Wisconsin Department of Transportation

Proposal #21: 2704-00-76
Wisconn Valley Way, V MT Pleasant
CTH KR to STH 11
Local Street
Racine County

This is Addendum No. 01, which provides for the following:

ADDENDUM NO. 01
Project ID 2704-00-76
March 1, 2019

Addendum No. 01
 ID 2704-00-76
 Revised Sheet 32
 March 1, 2019

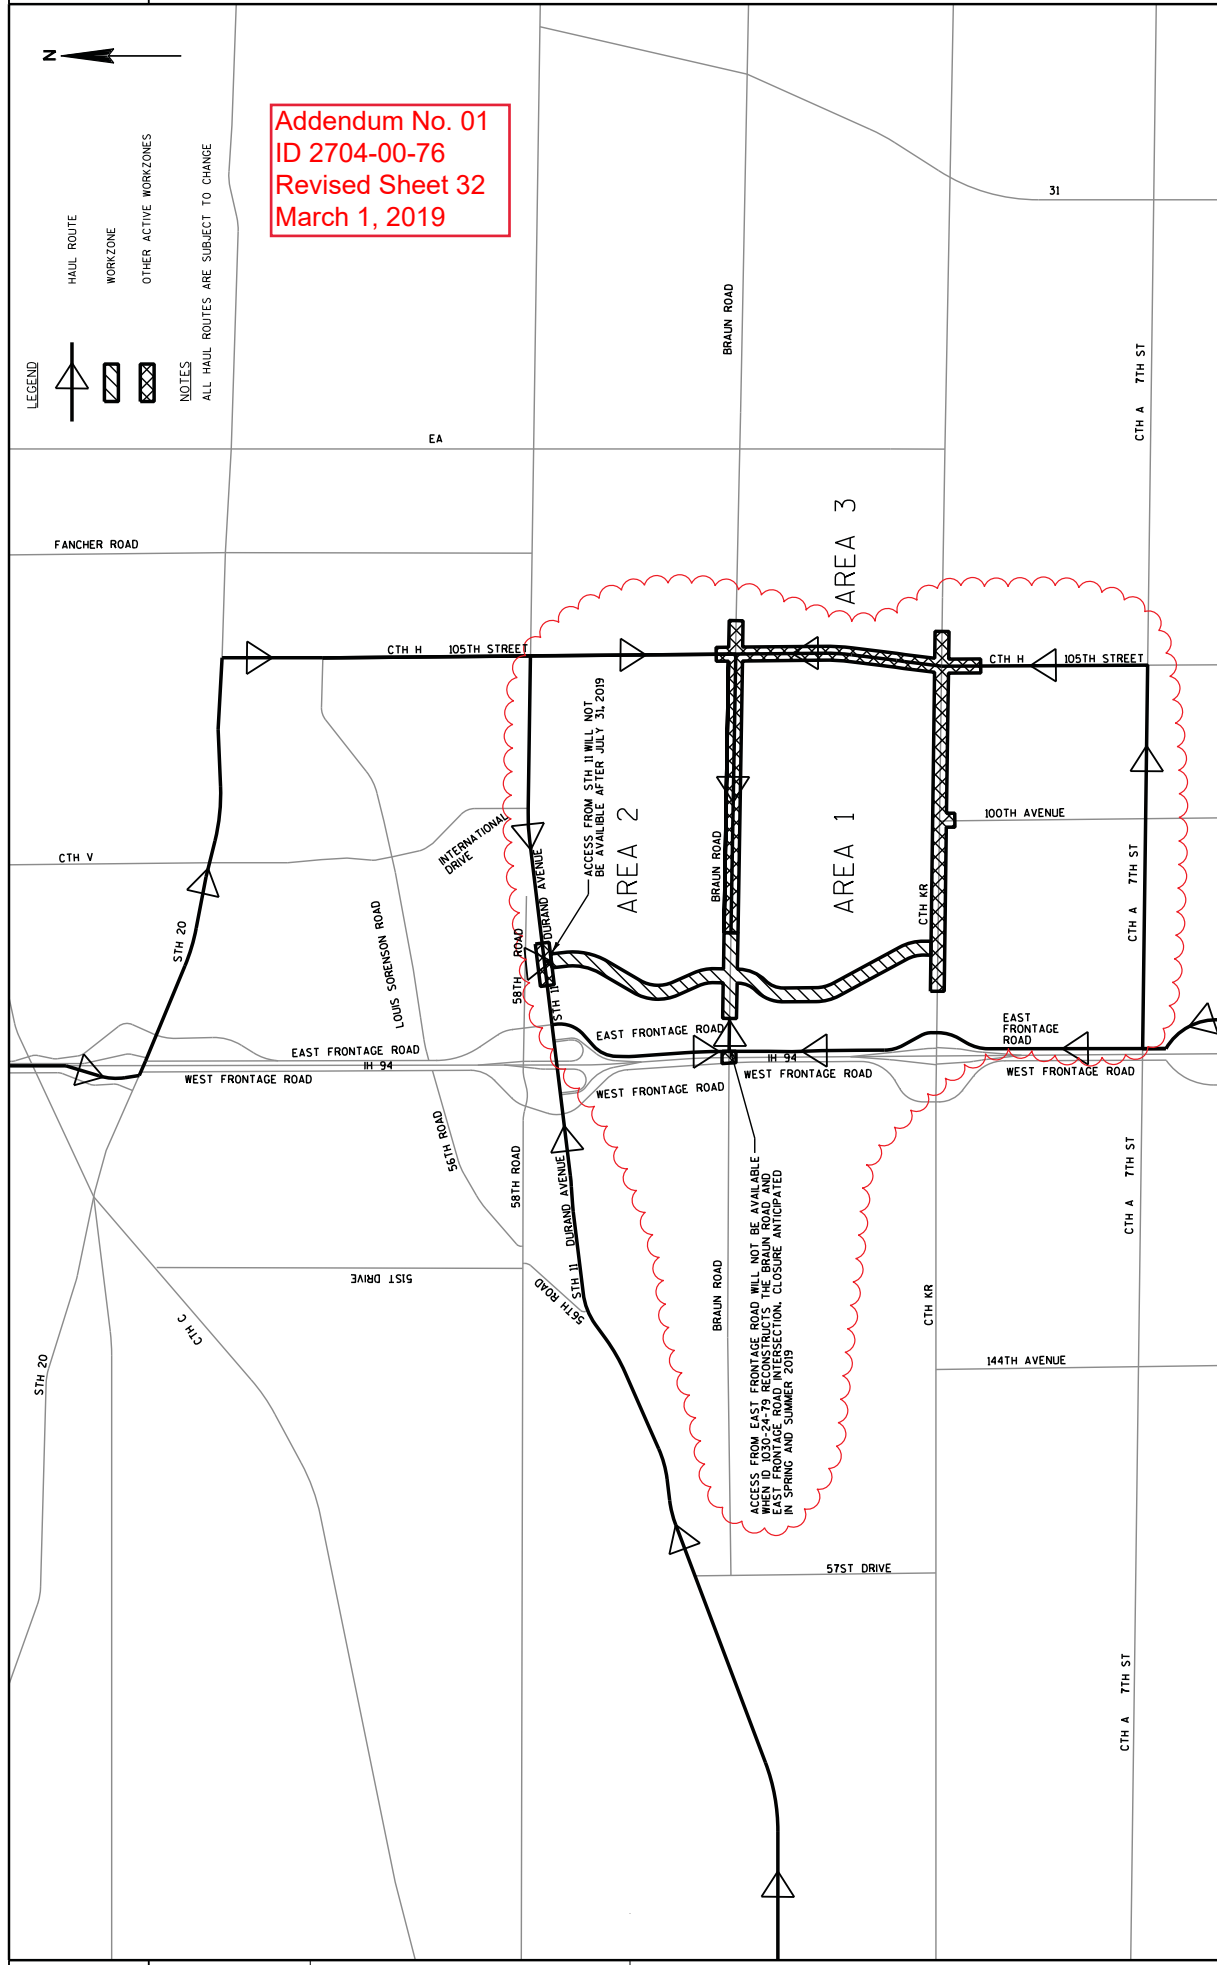
Revised Plan Sheets	
Plan Sheet	Plan Sheet Title (brief description of changes to sheet)
32	Construction Detail (updated "Haul Routes" to access construction site)
204	Traffic Signal Plan (updated plan view and legend)
229	Alignment Diagram (updated bearing call-out)
292	Miscellaneous Quantities (added 'Utility Removals' table)
293	Miscellaneous Quantities (updated 'Summary of State Furnished Materials' table)
297	Miscellaneous Quantities (updated 'Concrete Bases' table)
301-302	Miscellaneous Quantities (updated 'Cast Bases, Poles, Standards, Monotubes, Push Buttons, and Luminaires' table)
335	Plan and Profile (added "Remove Wood Pole" call-out)
